INITIAL FIRE SAFETY INSPECTION REPORT

M.M. Knitwear Ltd. (Extension 2)

RSC ID: 26630

Date: 18-May-2026

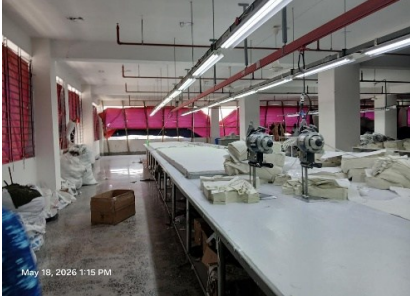
SI No.	Category	Findings	Required Action	Remediation Time Frame
F-01	Means of Egress	The exit stairs are not separated from [work areas, other spaces] on each floor by fire-rated construction. Location(s): All exit stairs, Building 5 (Part-B). Non-Compliance: Unprotected opening with exit stair enclosures, unsealed penetration due to standpipe and sprinkler pipe, installation of fire door not completed yet etc.	The exit stair enclosure shall be provided with a minimum of 2- hr. fire resistance rating for buildings 4 or more stories. Provide 1.5 hr. fire rated door and seal all penetrations and openings by 2 hr. fire rated fire rated barrier construction for buildings with 4 or more stories in accordance with section 6.3.1.2 of RSC Technical Guidelines (Standard)¹ V1.0. Provide a fire-resistive rated assembly between the exterior exit stairs and the building up to 10 ft. beyond the end of the stair to achieve the required separation. The rated assembly shall be approved and/or designed by a qualified fire protection engineer. Ensure that the fire doors are self-closing and positive latching, and that they are provided with fire exit (panic) hardware where serving production floors. If fire doors are required to be held open for functional reasons, provide automatic closing devices tied to the fire alarm system. Keep proper datasheet & certifications for installed fire doors & accessories on-site for verification. The clearance under the bottom of a door shall be a maximum of 3/4 in. (19 mm). Ensure that the listing labels are clearly visible for the installed fire doors.	Within 3 Months

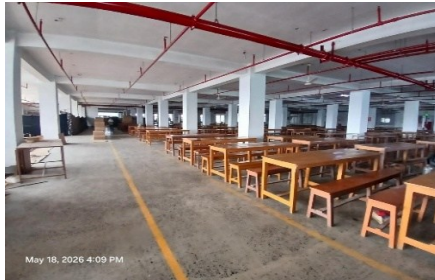
F-02	Means of Egress	Fire evacuation maps are not updated and provided as per site condition. Location(s): Building 5 (Part-B).	Update the fire evacuation map and shall be posted at the entrance to each exit stair in accordance with RSC Technical Guidelines (Standard)¹ V1.0 Section 13.3.	Within 3 Months

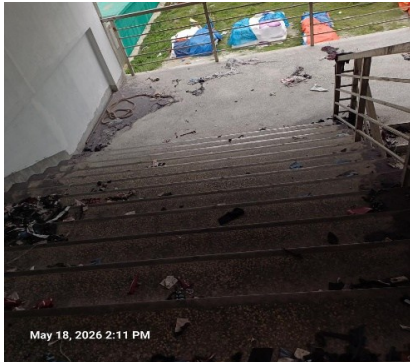
F-03	Means of Egress	Changes in level was found 24 in. where RSC Technical Guidelines (Standard)¹ V1.0 Section 6.9 or 6.10 doesn't meet. Location(s): Stair-2 (N-W), Building 5 (Part-B).	Changes in level exceeding 535 mm (21 in.) in elevation shall meet the requirements for stairs in 6.9 or ramps in 6.10. The change in level shall be readily apparent and if not, marked with additional signage or floor markings.	Within 3 Months

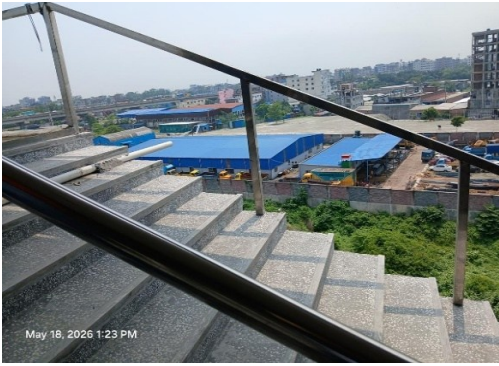
F-06	Means of Egress	Based on the number and location of emergency lights observed, adequate illumination levels are not anticipated along egress routes. Location(s): All floors, Building 5 (Part-B).	Test the emergency lighting system on each floor and provide additional emergency fixtures to provide adequate illumination along the means of egress. Provide a minimum illumination of 10 lux at the floor level within exit stairs and exit discharge paths, and minimum 2.5 lux along exit access aisles. Illumination on means of egress shall meet in accordance with RSC Technical Guidelines (Standard)¹ V1.0 Section 10.12.2.	Within 3 Months

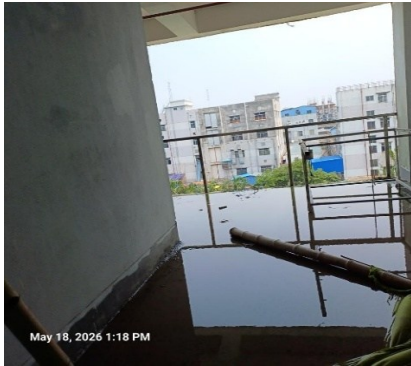
F-07	Means of Egress	Directional signs are not provided where direction of the path of travel to an exit has changed. Location(s): All floors, Building 5 (Part-B).	Illuminated directional signs shall be provided where there is a change in the direction for the path of travel and the direction to an exit is not obvious in accordance with RSC Technical Guidelines (Standard)¹ V1.0 Section 6.11.3.	Within 1 Month
 May 18, 2026 1:15 PM  May 18, 2026 4:09 PM  May 18, 2026 1:24 PM

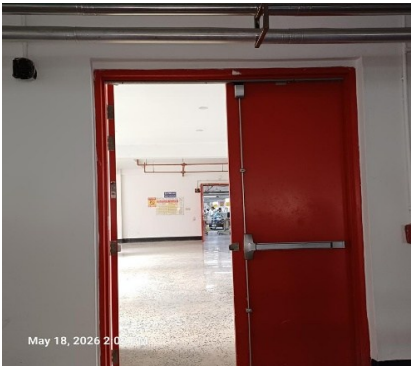
F-08	Means of Egress	Handrails are not provided on both sides of each exit stairs. Having handrails on one side of said staircase, may pose as a falling hazard during evacuation. Location(s): Building 5 (Part-B).	Provide handrails on both sides of the exit stair. New handrails shall have a minimum height of 865 mm (34 in.) and a maximum height of 965 mm (38 in.) as measured from the leading edge of the tread. Intermediate handrails shall be provided when the stair width exceeds 2.2 m (87 in.). Open guards shall have intermediate rails or pattern such that a sphere 200 mm (8 in.) in diameter cannot pass through any opening up to a height of 865 mm (34 in.). Handrail shall construct in accordance with RSC Technical Guidelines (Standard)¹ V1.0 Section 6.12.	Within 3 Months

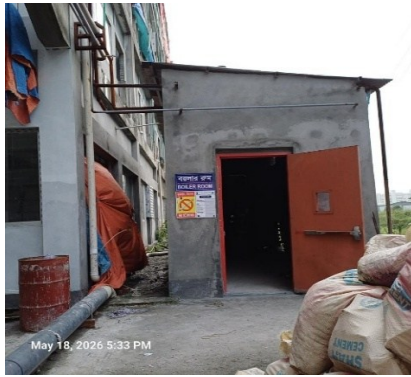
F-21	Fire Rated Construction	Rooms used for storage of combustible materials are not separated from the surrounding occupancy/areas. Location(s): 5th, 2nd, 1st, Ground floor, Building 5 (Part-B).	Rooms used for storage of combustible materials shall be separated from the surrounding occupancy with a minimum 1 hour construction in accordance with section 3.4.2.1.5 of RSC Technical Guideline (Standard).	Within 3 Months
		 May 18, 2026 1:45 PM	 May 18, 2026 4:01 PM
